**TRANSMITTAL OF DENNIS WILLIAMS'  
COMMENTS ON WATERMASTER'S  
LONG TERM PLAN**

**Expert Report of  
Dennis E. Williams Ph.D.**

**COMMENTS ON CHINO BASIN WATERMASTER'S  
PROPOSED LONG TERM PLAN FOR THE  
MANAGEMENT OF SUBSIDENCE IN MZ-1**

Figure 26

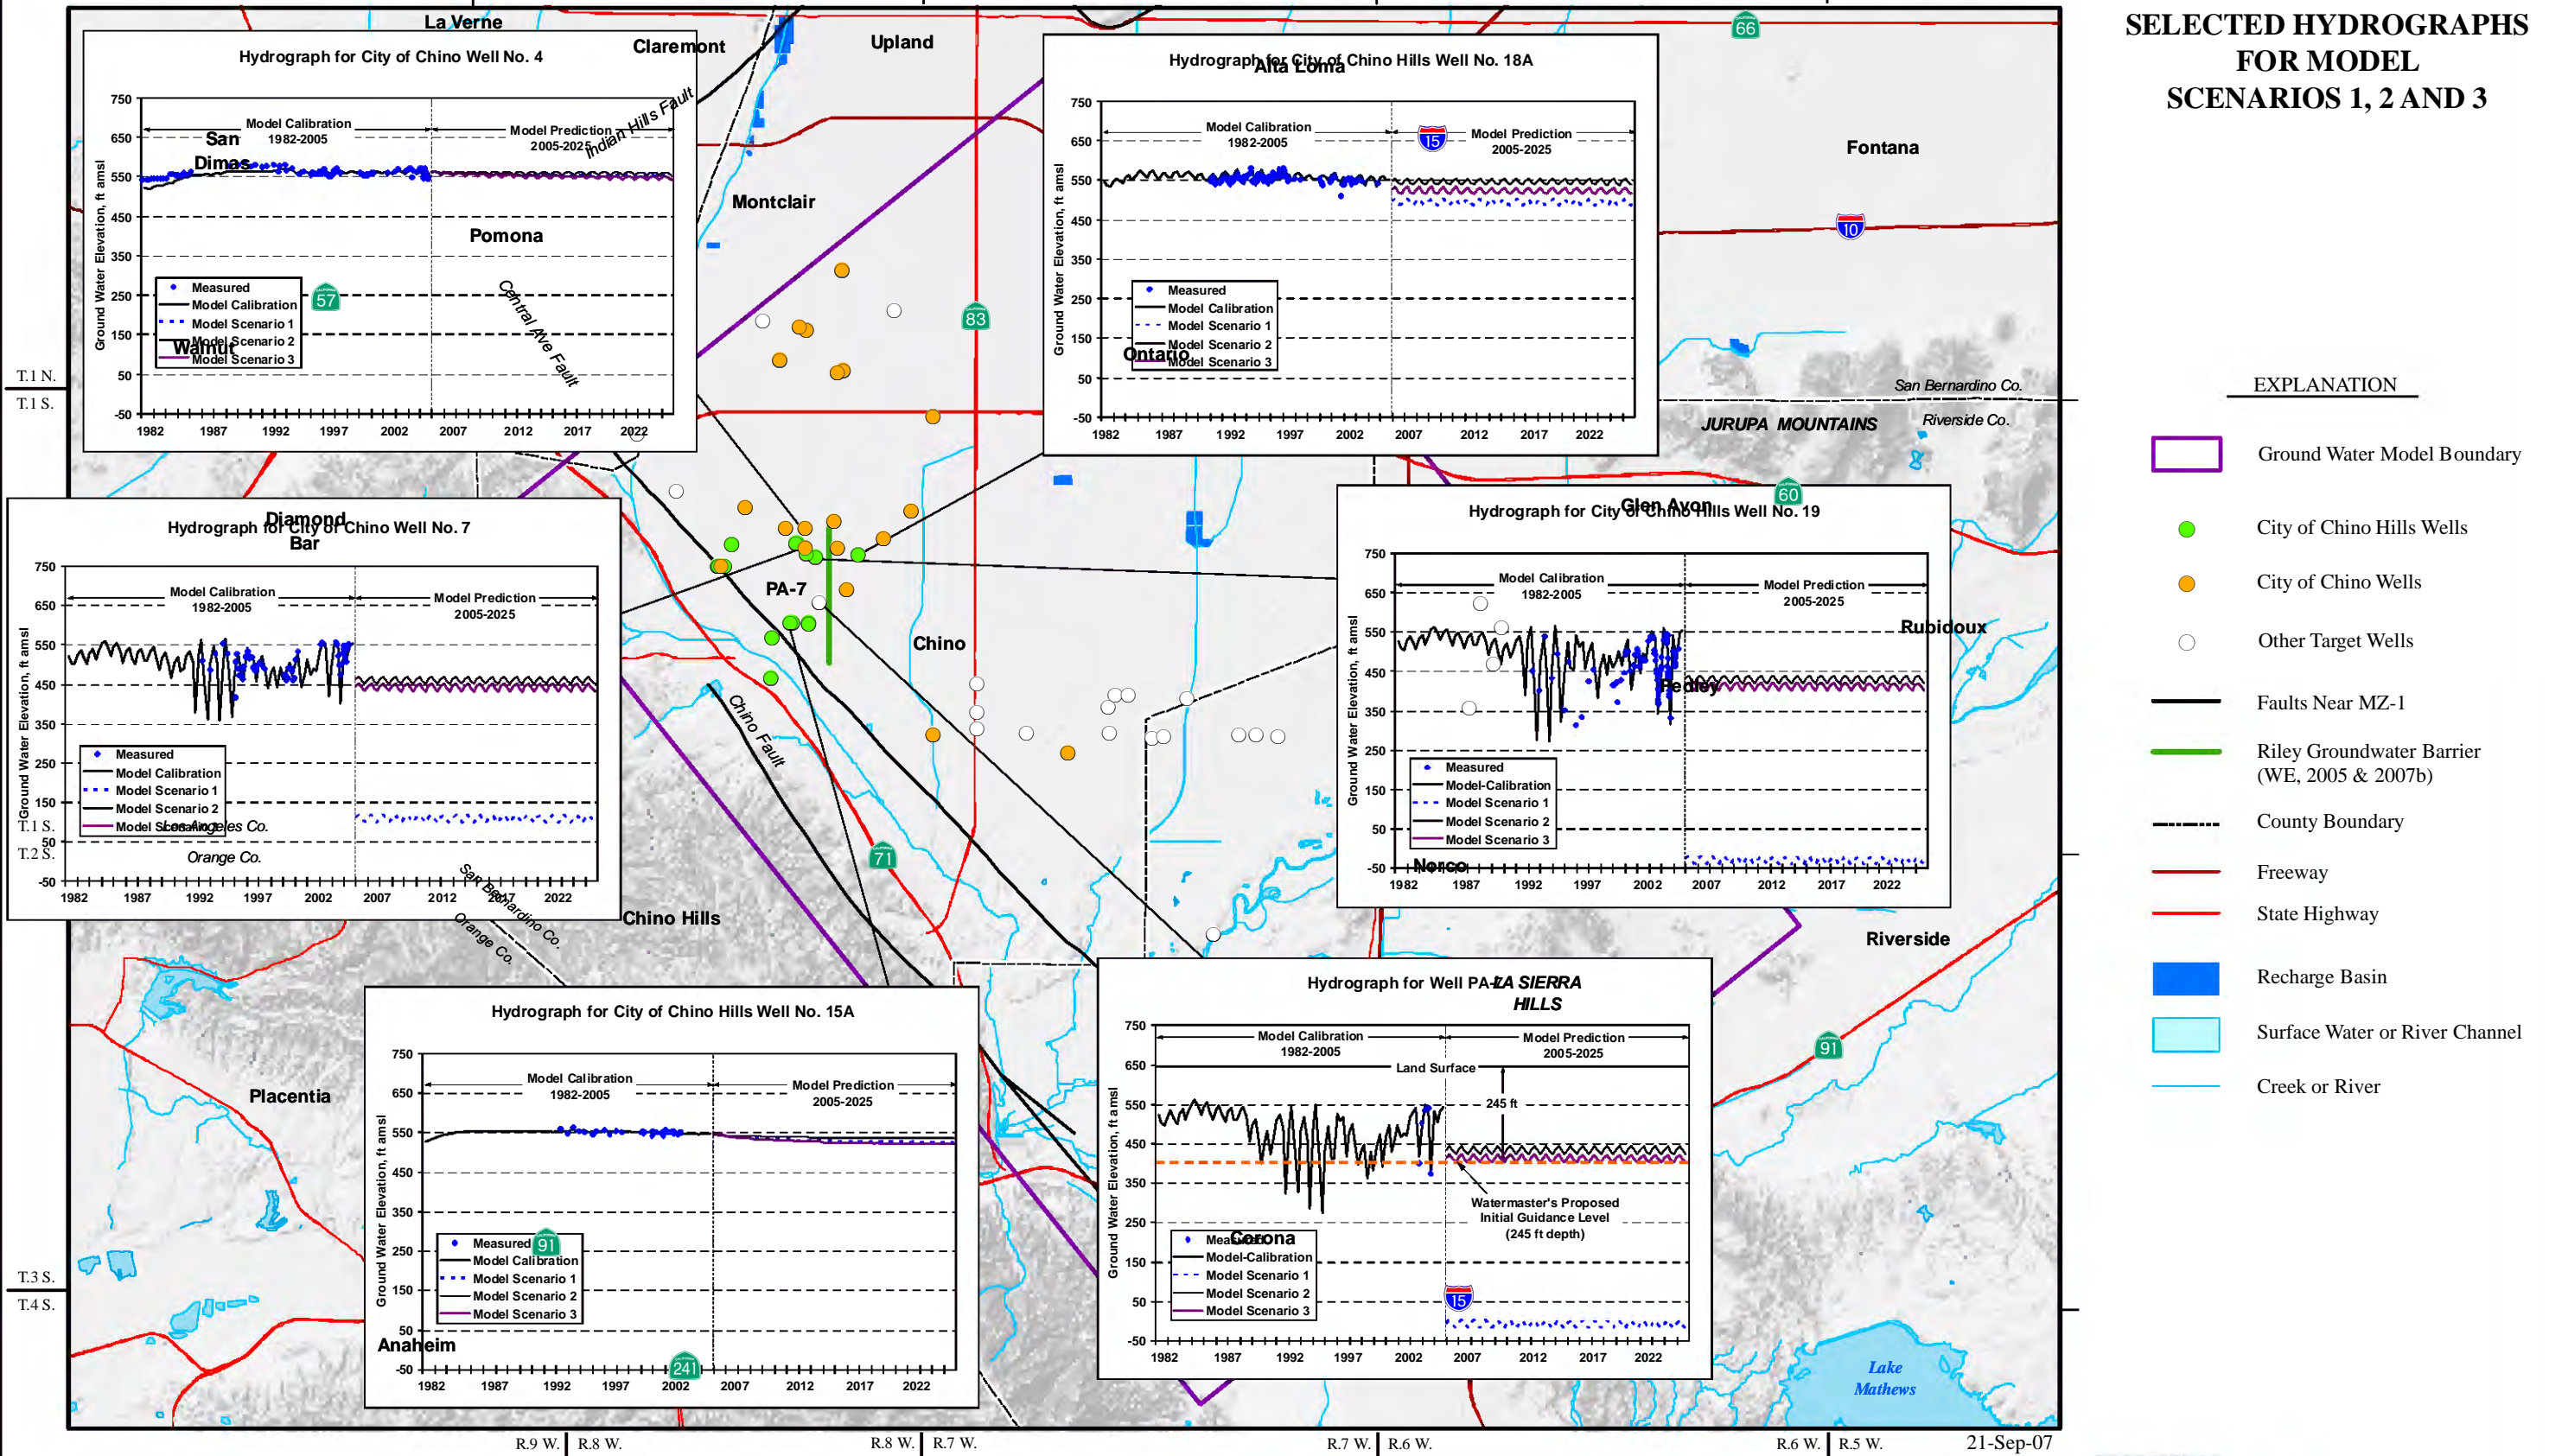
117. Ground water level differences between the current level and the end of model simulation of each the model scenarios were plotted to show the potential impacts from the various pumping schedules for the City of Chino Hills' wells (see Figures 23 through 25). Selected hydrographs for these model operational runs are shown on

1 Figure 26. Depth to water in PA-7 was plotted to compare the model-predicted level to  
2 the proposed Guidance Level (see Figure 27).
